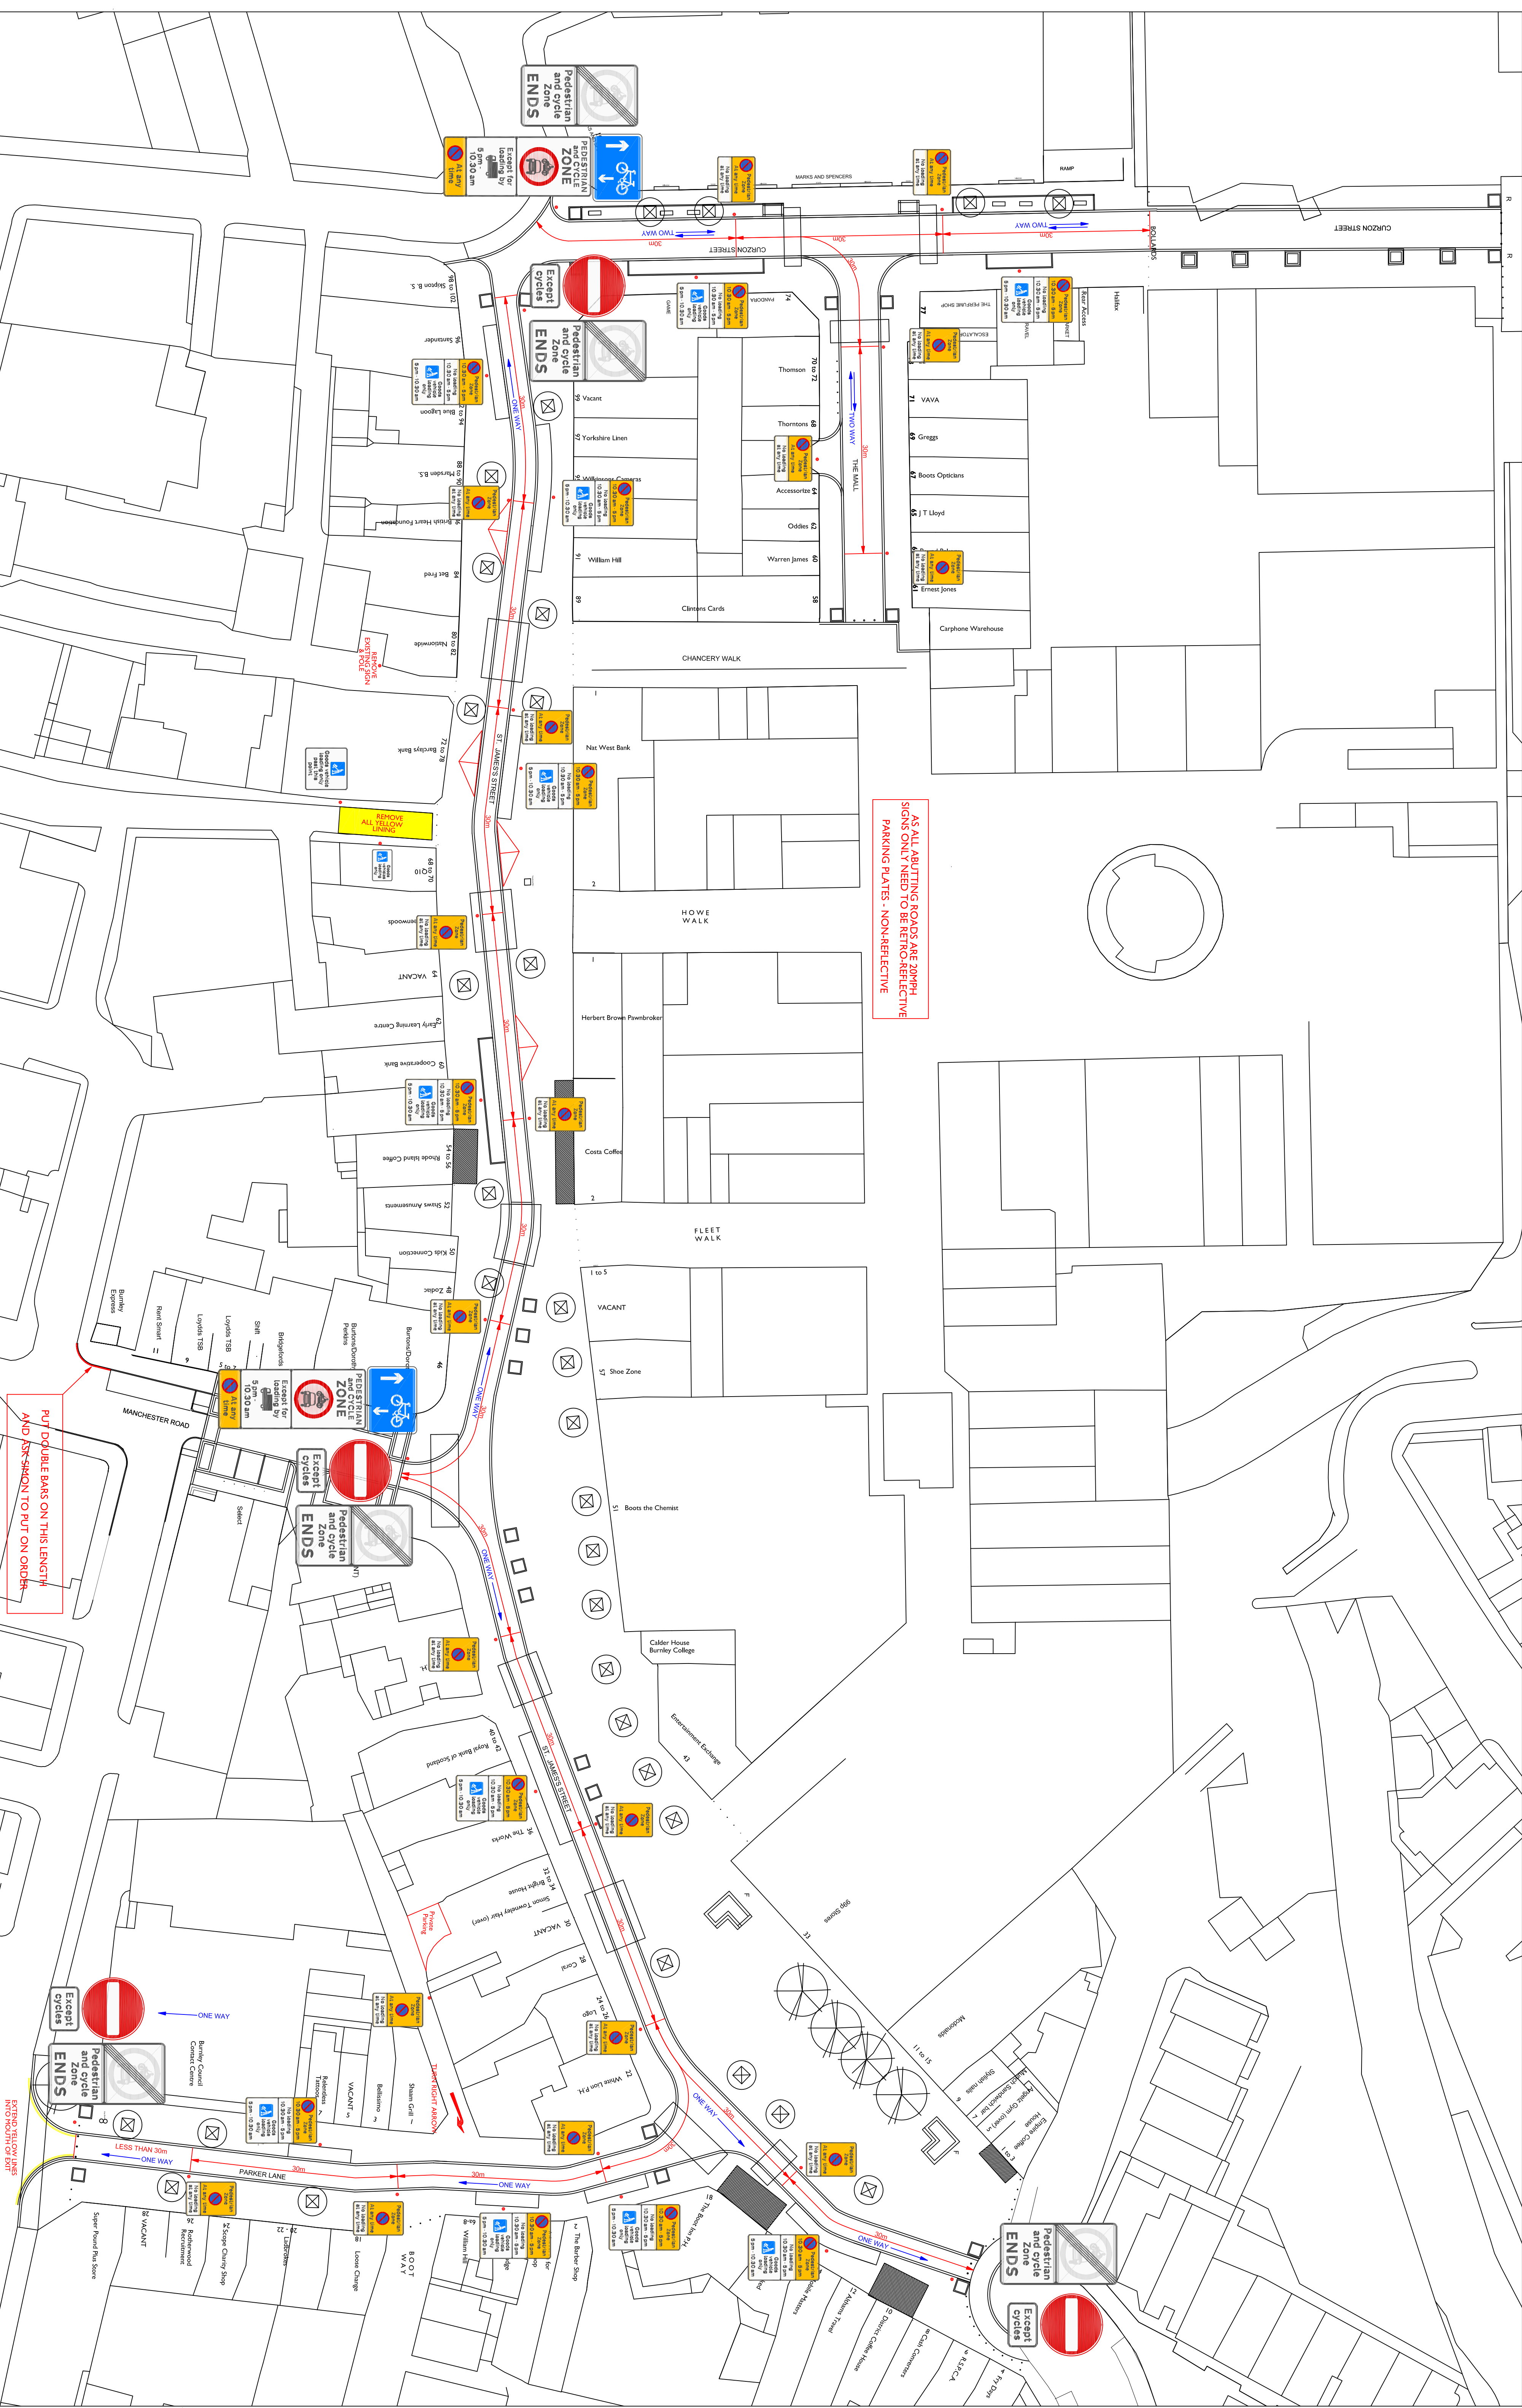
AS ALL ADJUTING ROADS ARE 30MPH
SIGNS ONLY NEED TO BE RETRO-REFLECTIVE
PARKING PLATES - NON-REFLECTIVE

PUT DOUBLE BARS ON THIS LENGTH
AND ARROW TO PUT ON ORDER

REMOVE ALL YELLOW
SIGNS
